No.2 Dock Stonework Repair Works

Clarifications and Responses Issue 1

Issue 2

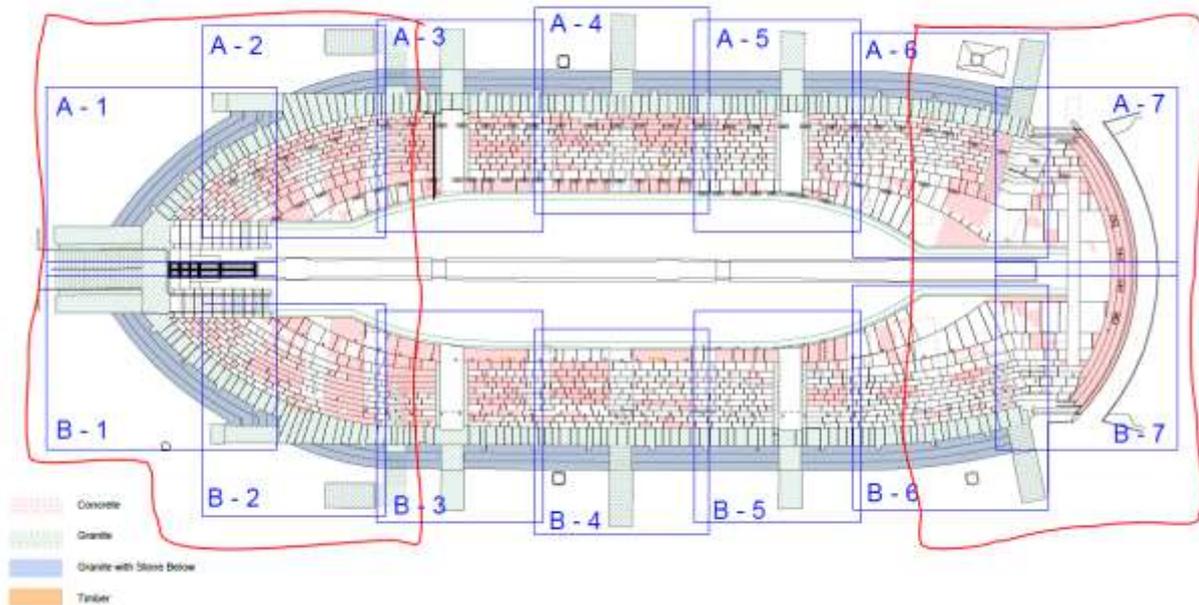
Q: "Appendix 4 Drawing – following on from query 2 above, this drawing shows the purple hatching but not the red and notes that the purple hatching refers to ‘phase 1 area of work, repairs to be done outside of this’. Furthermore, there are areas coloured purple noted ‘previous stone and mortar repairs’ but there are many of these shown in the areas which are hatched red on Appendix 3 Drawing.

Also, on this drawing there are many repairs coloured green noted ‘stone/mortar repairs required’ but are in the purple hatched area noted ‘phase 1 area of work, repairs to be done outside of this’.."

Q: Appendix 1 Pritchard Architecture Report – this document shows all repairs but, depending on the answers to items 2 and 3 above, is not, as such, a schedule of work. The first page, the overall plan, is split into 14 zones, A1 to A7 and B1 to B7. Part of A2, A6, B2 and B6 seem to fall within the purple hatched area mentioned in the above queries. We note that all areas are shown on the subsequent pages with sizes and photographs of all (most) repairs. Please clarify which zones of work are to be included within this tender.

A- Yes, on Appendix 4 drawing, the purple hatched areas are the north and south areas outside of the scaffolded area. These are the two areas we would like a fee for primarily. The numerous small areas coloured solid green and solid purple were drawn by Giles Pritchard Architects, following installation of the ship props, from 2017-2019. So it would be primarily the green areas that require completing, while checking the purple areas to see if they require any further work.

A- The areas to north and south of the scaffolded area, will include: A1, A2, small margin of A3, part of A6 and A7, B1, B2, small margin of B3, part of B6, B7. Please note these are to be stonework repairs completed on the steps below the granite paved broad altar walkway only and not of the walls above. If the stonework within the Phase 1 scaffolded area was to be tackled in addition, this would include: remainder of A3, A4, A5 and remainder of A6, remainder of B3, B4, B5 and remainder of B6. Please see image below.
